Technical Information	Date: 09.07.2026 Official: Marier Department: BT-EL/PRM1.1
------------------------------	--

Tech. Information No.	2728 / 2026
Subject:	FSP-5000-RPS version 5.15.28 release

Short description:	Re-introduction of logical input 5 for FLM-420-RLE-S
---------------------------	--

FSP-5000-RPS: input configuration for sprinkler monitoring interface

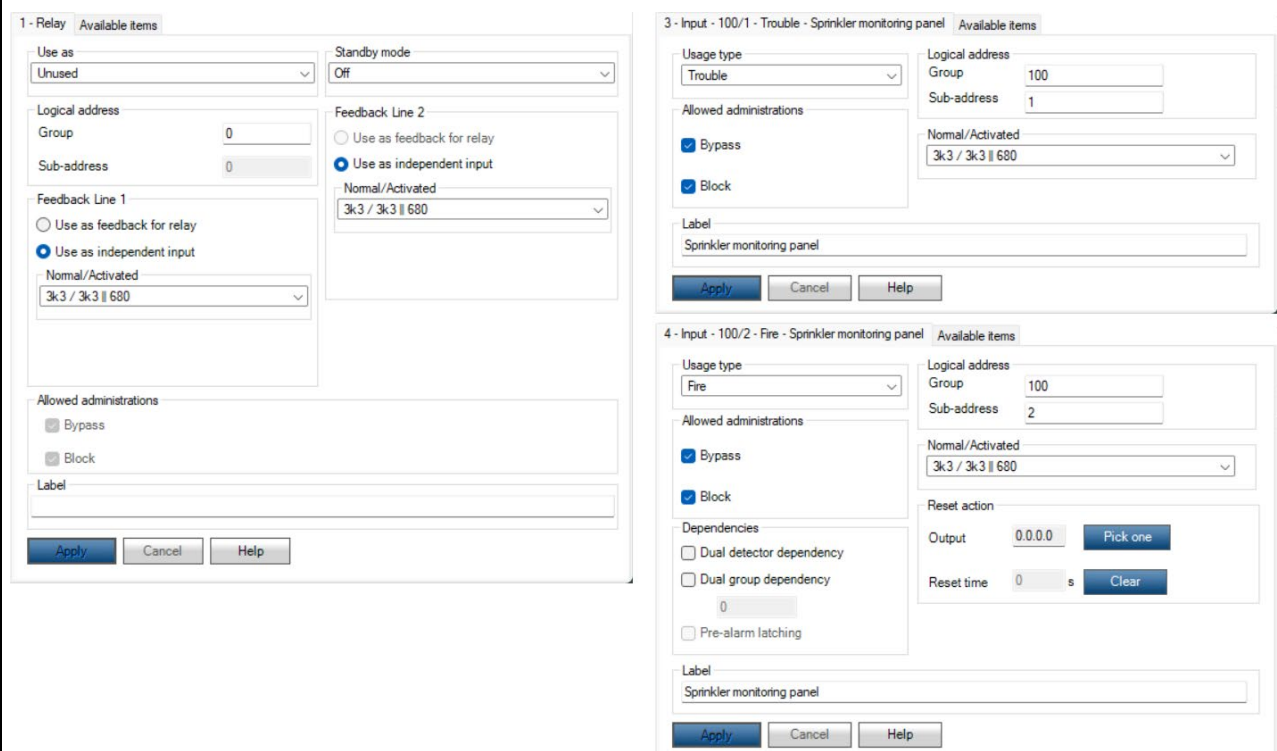
The output of the RLE module is set to **Unused** while both inputs (Feedback line 1 & 2) are set to **Use as independent input**. When the RLE module is not installed adjacent to the sprinkler monitoring panel, the line monitoring setting of both inputs **Normal/Activated** must be set to **3k3 / 3k3 || 680**. To receive the fault condition, set one input to usage type **Trouble**. To receive the activation condition, set the other input to usage type **Fire**. Depending on the customer requirements, other usage types can be chosen.

FSP-5000-RPS: output configuration for gas extinguishing system

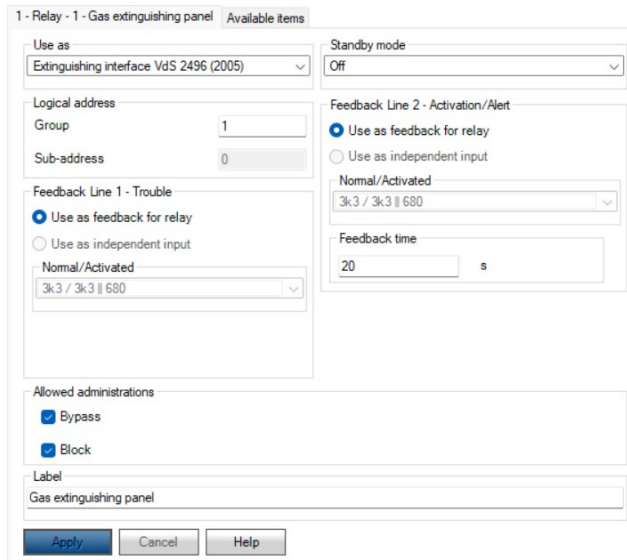
The output of the RLE module is set to **Extinguishing interface VdS 2496 (2005)**. As a result, both inputs are automatically set to **Use as feedback for relay** with the line monitoring setting **Normal/Activated** set to **3k3 / 3k3 || 680**.

With this output setting, the inputs 1 and 2 are automatically set correctly to monitor the gas extinguishing system by AVENAR in compliance with VdS 2496. No need to apply additional settings to feedback input 2 (logical input 5).

FSP-5000-RPS: example of usage of the activated and fault condition of the extinguishing system in rules

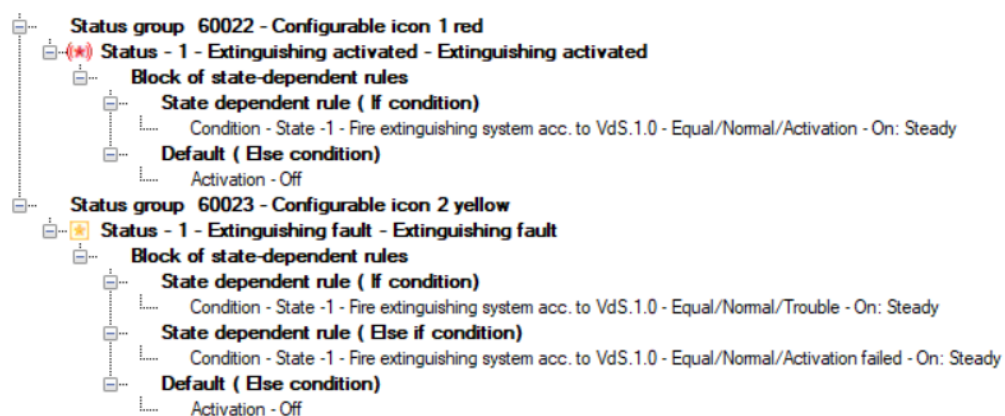
According to VdS 2496 it is not allowed to generate a fire alarm condition on AVENAR panel when the extinguishing system is activated by a manual release device. (by pressing a yellow call point connected to the fire extinguishing panel → no fire detected by AVENAR panel). As a result, it is mandatory to set the re-introduced feedback input 2 (logical input 5) to **Usage type: unused**. When a usage type is set for input 2 (logical input 5), the RPS consistency check will generate the following warning: *"This is not compliant according to VdS 2496. In case you want to comply, please change the input to Unused."*

In case you want to use the 'Activated condition' and/or 'Fault condition' of the extinguishing system in RPS for counters and rules, e.g. transmission to the fire brigade using the transmission device (UE) connected to AVENAR panel, use the **activating element type: Fire extinguishing system**. For the activated condition use the logical compound state: **Activation**, for fault condition combine the states **Trouble** and **Activation failed**.
